# Access Compliance Report

## Public Rights-of-Way (Curb Ramps)

Intersection ID: 31190	Main Street: CROFT_HAVEN_DR	Cross Street: DAVIS_RIDGE_DR	Location: SE
ADA ID: 3BD77FD8496B	Ramp Type: PerpDiag	Initial Pass/Fail: Fail	Overall Compliance: No
Severity Score: 8.75			
Codes/Mitigation Info/Possible Solution		Field Measurements/Component Compliance

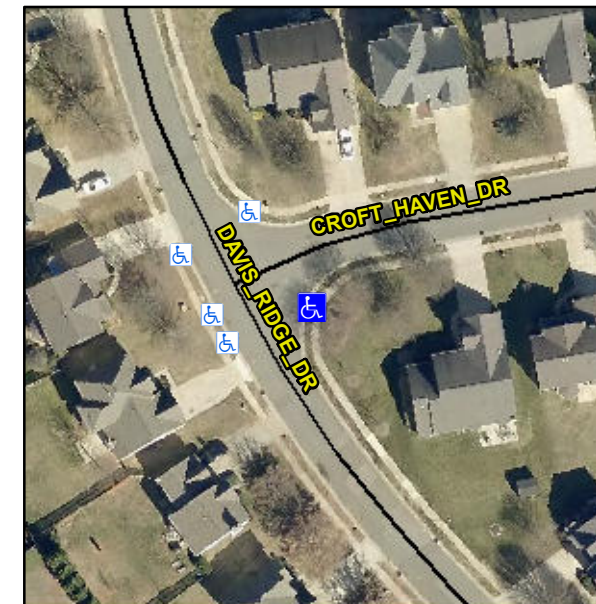
**Not Found, R304.5.1**

Compliance	Description	Data	Compliance	Description	Data
N/A	Ramp Length (in)	48.0	Yes	Ramp Slope (%)	5.5
No	Ramp Width (in)	47.5	Yes	Ramp XSlope (%)	0.2
N/A	Flare Type LT	N/A	N/A	Flare Type RT	N/A
N/A	Flare Slope LT (%)	N/A	N/A	Flare Slope RT (%)	N/A
N/A	Flare Traversable LT?	N/A	N/A	Flare Traversable RT?	N/A
N/A	Landing Length (in)	N/A	N/A	DWS Provided?	N/A
N/A	Landing Width (in)	N/A	N/A	DWS Contrast?	N/A
N/A	Landing Slope (%)	N/A	N/A	DWS Length (in)	N/A
N/A	Landing X Slope (%)	N/A	N/A	DWS Full Width?	N/A
N/A	Landing Curb? (Y/N)	N/A	N/A	DWS Offset (in)	N/A
N/A	Shared Landing?	N/A			
N/A	Gutter Ponding?	N/A	N/A	Gutter Slope (%)	N/A
N/A	Gutter Lip Ht (in)	N/A	N/A	Gutter X Slope (%)	N/A
N/A	Painted X Walk1?	No	N/A	Painted X Walk2?	No
	X Walk 1 Direction	To N		X Walk 2 Direction	To W
N/A	X Walk 1 Width (in)	N/A	N/A	X Walk 2 Width (in)	N/A
	X Walk 1 Slope (%)	6.1		X Walk 2 Slope (%)	3.8
	X Walk 1 X Slope (%)	0.8		X Walk 2 X Slope (%)	6.5

**Remove & Replace Curb Ramp With Two New Directional Ramps or Equivalent.**
